From: Marge Schmuckal  
To: Ethan Boxer-Macomber  
Date: **10/11/2005 2:51:05 PM**  
Subject: Ronald McDonald House

**date:** 3/31/2006  
**project:** RMDH PHASE II: 2004-0320  
**subject:** Parking

**Ronald McDonald House**

**date:** 5/4/2006  
**project:** RMDH PHASE II: 2004-0320  
**subject:** Additional Permit Information

The attached sketch shows the locations of 8 total parking spaces. 6 inside the garage and 2 adjacent to the house on Carleton Street.

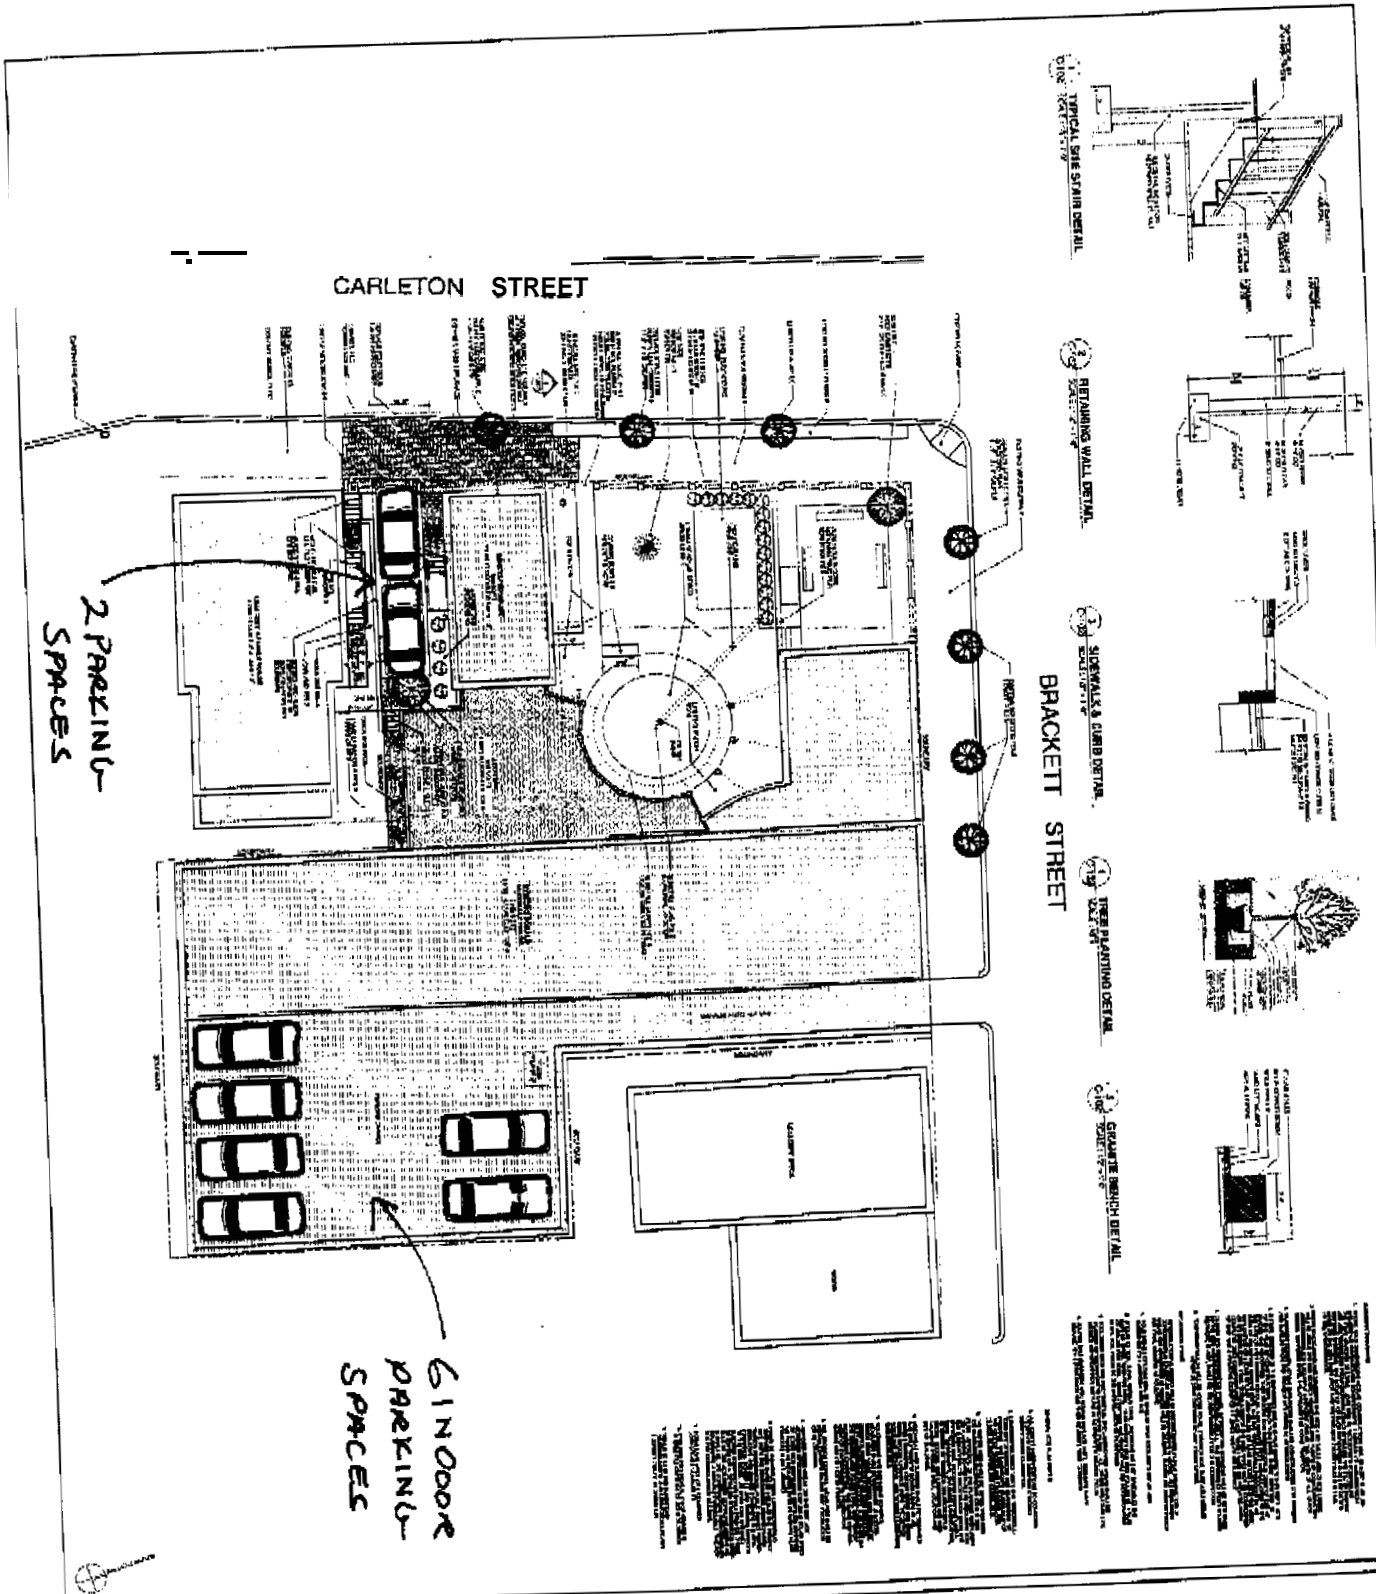
Sarah,  
I'm a little confused. The original submittal stated that there were 8 parking spaces being provided on site. Based on the manager's unit, 600 sq. ft of office space, 21 lodging units, 7.2 or seven spaces are required. On the currently plans that I have only 6 parking spaces are being shown. What happened to the other two parking spaces? One of those is required.

**SK-1**

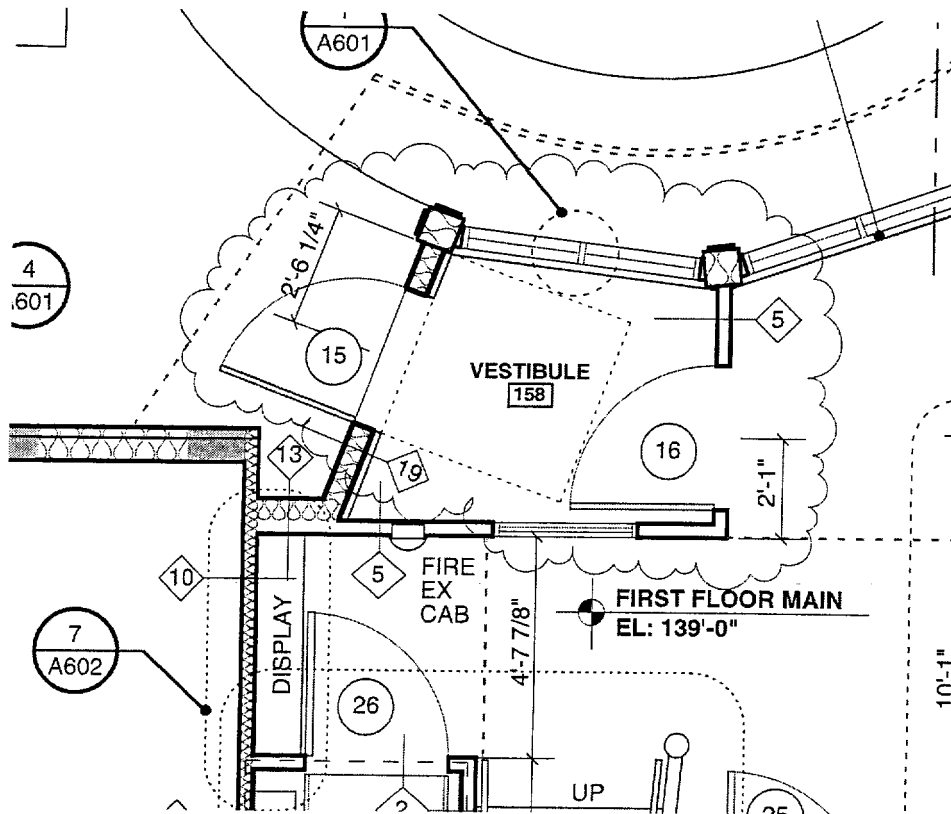
- A-101 SK-1 Revised entry vestibule dimensions to meet ADA clear door area requirements.
- A-102 SK-2 Revised door schedule. **All** doors at stair shall be 60 minute fire rated.
- A-600 All ceramic wall tile shall be 38" high.
- A-601 SK-3 Stair nosing: All new stair nosings shall match this detail with a max 30deg bottom slope per ADA.

*SIAN*  
*SK-10 & 11*

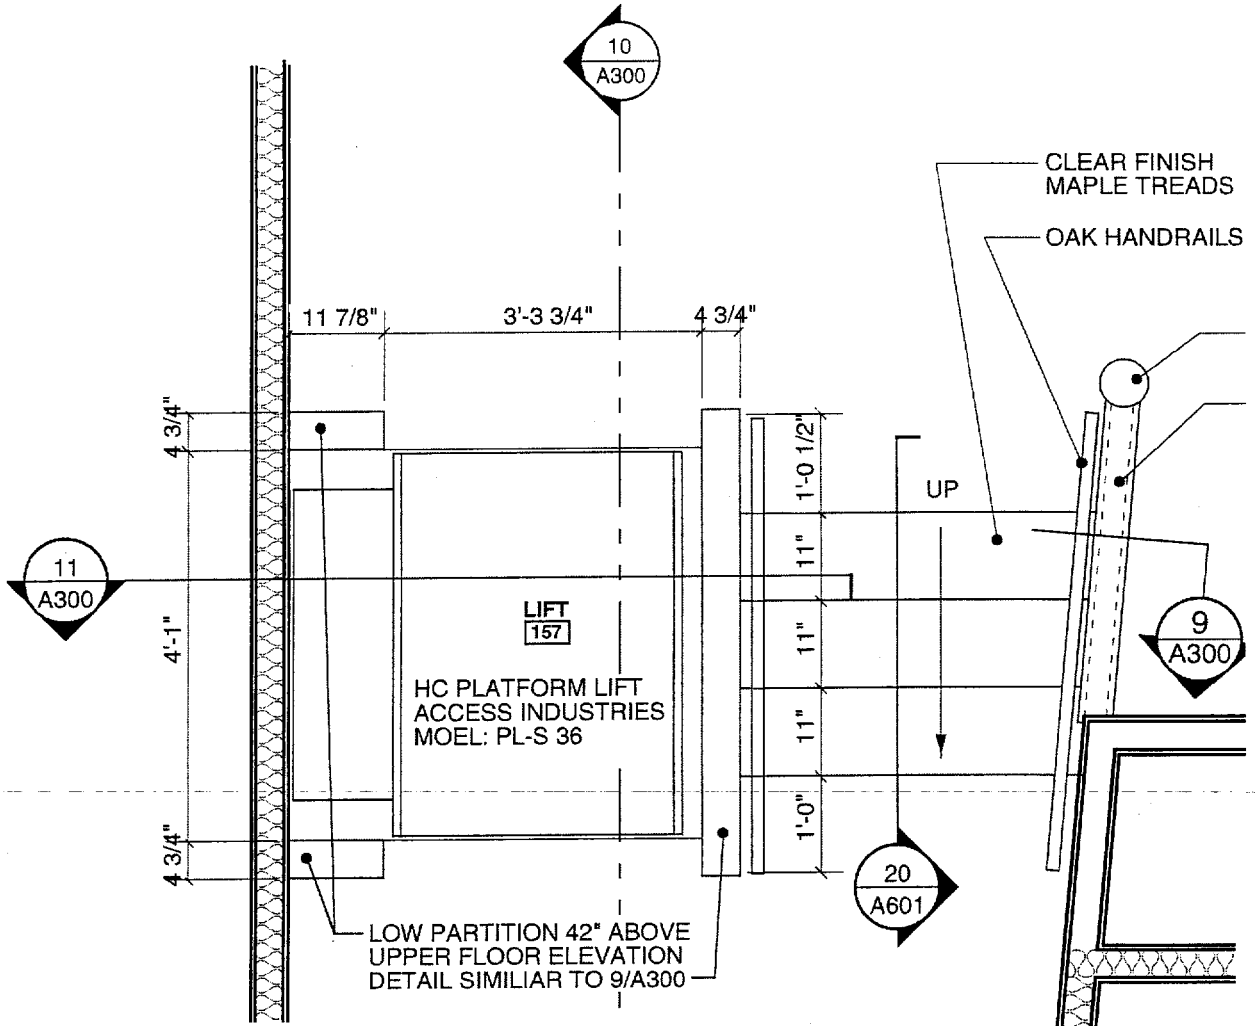
A-300 SK-10 Handrail Detail Section top of handrail shall be at **3'-0** above tread nosing.

**A-300** SK-11 Stair/Lift **Plan** includes information for the Access Industries lift. This lift does not require a rated shaft enclosure or doors at the top and bottom landings.

- 6) Stairway nosing. See attached SK-3 for revised nosing profile.
- 7) Handrail detail. See attached SK-10 for revised handrail mounting height.
